ISOLATED ANALOG OUTPUT OPTION

New INF-B / DP41-B

Older-Style INF / DP41

These changes are the result of the following product enhancement:

Isolated Analog Output Option Card

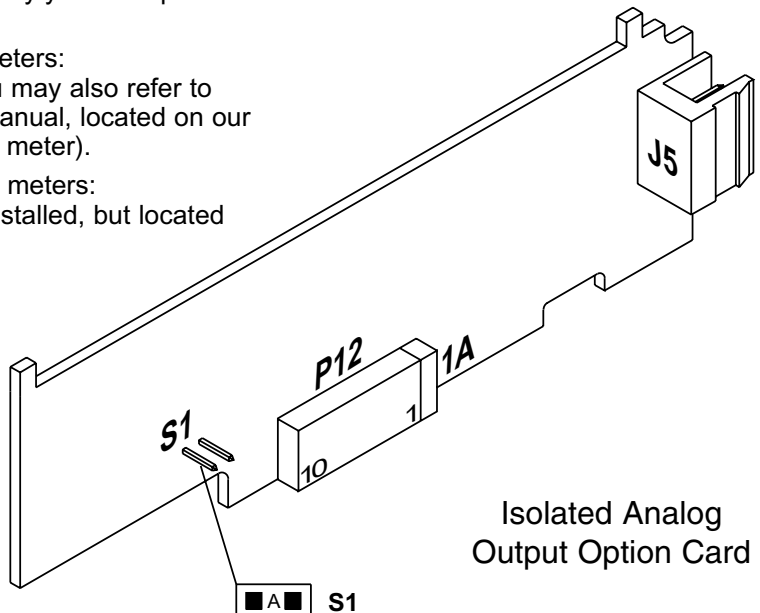
For this option card to work properly you must position the jumper **S1** as detailed below.

- For **New INF-B / DP41-B** meters: S1-A must be installed. You may also refer to the Analog Output Option Manual, located on our website (as listed on side of meter).
- For **Older-Style INF / DP41** meters: S1-A does not need to be installed, but located in a storage position.
